**Re: Proposed Section 278 Works for the Development off Rowley Lane, Fenay Bridge**

Haigh Huddleston Associates Ltd have been appointed as designers for the Section 278 works at above residential development. This report has been prepared in accordance with GG119 as a response to the Stage 1 Road Safety Audit undertaken by Local Transport Projects on December 2024.

## Road Safety Audit Decision Log

**Problem 2.2.**

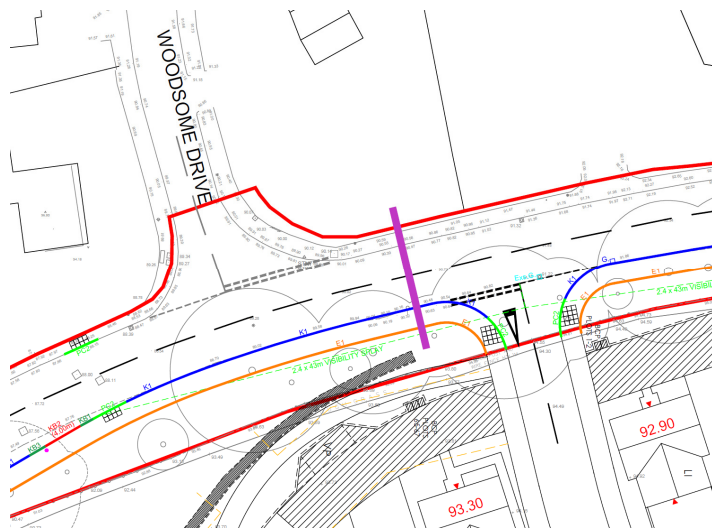
**Observations** – The southern boundary of Rowley Lane is currently flanked by extensive trees and vegetation. The proposed works show the provision of a new footway with a tactile crossing point at the eastern extents. It is not clear from the drawings whether an adequate forward visibility splay to pedestrians waiting to cross will be provided (or if the visibility splay from the crossing point to approaching vehicles will be suitable). If adequate splays are not provided and protected, then there could be an increased risk of pedestrian / vehicle conflict.

**Recommendation** – It is recommended that adequate visibility splays to/from the proposed tactile crossing point are provided and maintained.

It is not possible to achieve a full 43m visibility splay at the current crossing location due to an existing stone wall which protrudes out from the banking. It is therefore recommended that the crossing point is relocated to a position where adequate visibility can be achieved.

Having explored multiple crossing locations we have determined that it is not possible to achieve a full 43m visibility splay to the east of the new site access junction.

It is therefore recommended that the pedestrian crossing is relocated between the new access junction and the existing junction with Woodsome Drive as shown in Purple below.

### 2.1 Problem

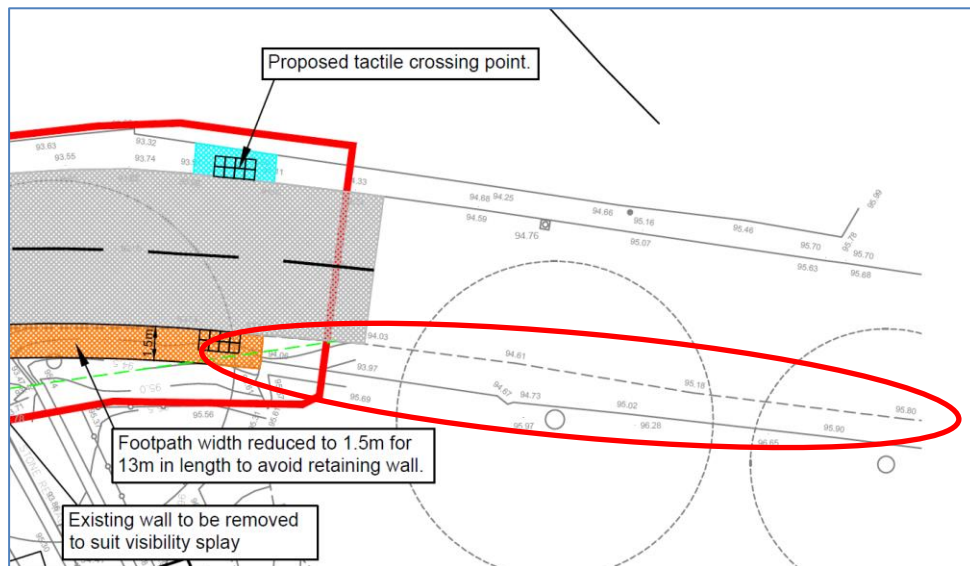
The southern boundary of Rowley Lane is currently flanked by extensive trees and vegetation. The proposed works show the provision of a new footway and the re-profiling of the existing bank. The proposed drawings show a 2.4m x 43m visibility splay at the site access although it is not clear whether the visibility splay will be protected within the proposed public highway extents or whether elements of the splays will be over private land. If the splays are not protected, then a reduced level of practical visibility could increase the potential for failure to give way type collisions.

It is recommended that the required visibility splays are entirely within the public highway without any vertical obstructions.

## 2.2 Problem

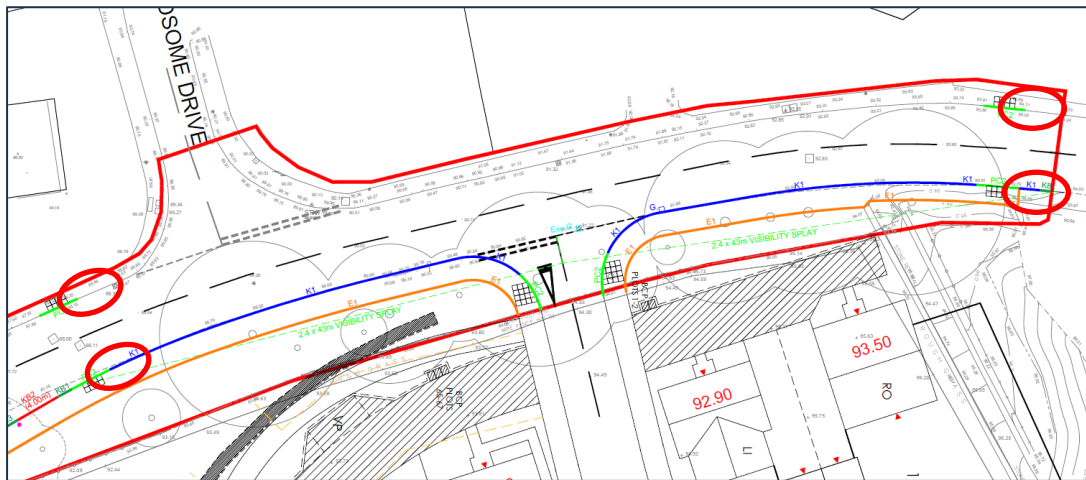
The southern boundary of Rowley Lane is currently flanked by extensive trees and vegetation. The proposed works show the provision of a new footway with a tactile crossing point at the eastern extents. It is not clear from the drawings whether an adequate forward visibility splay to pedestrians waiting to cross will be provided (or if the visibility splay from the crossing point to approaching vehicles will be suitable). If adequate splays are not provided and protected, then there could be an increased risk of pedestrian / vehicle conflict.

It is recommended that adequate visibility splays to/from the proposed tactile crossing point are provided and maintained.

## 2.4 Problem

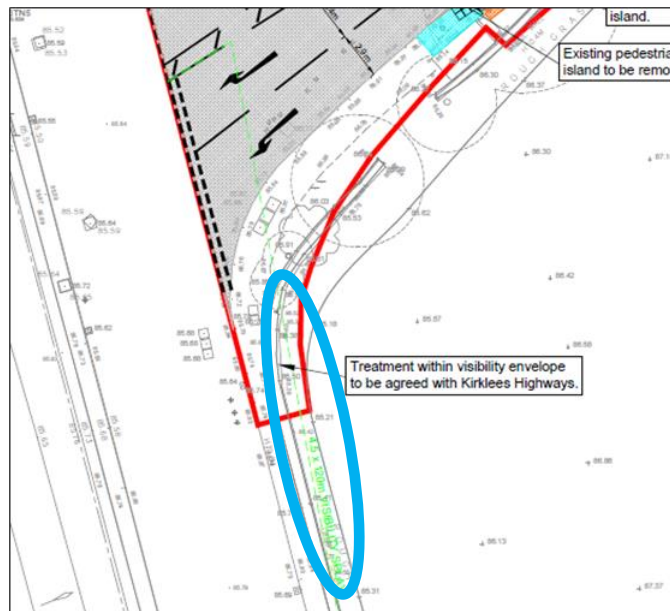
At the time of the site visit a left turning HGV was observed to encroach onto the northern Rowley Lane footway in order to make the left turn, mainly due to the existing pedestrian refuges. The proposed scheme provides a new pedestrian refuge further east but no vehicle tracking / swept path analysis has been provided to demonstrate that vehicles can successfully make the left turn without encroaching onto the footway.

It is recommended that appropriate vehicle swept path assessments are undertaken for the scheme at Penistone Road / Rowley Lane and also the site access junction and, if required, the design be suitably modified to accommodate the identified manoeuvring requirements.
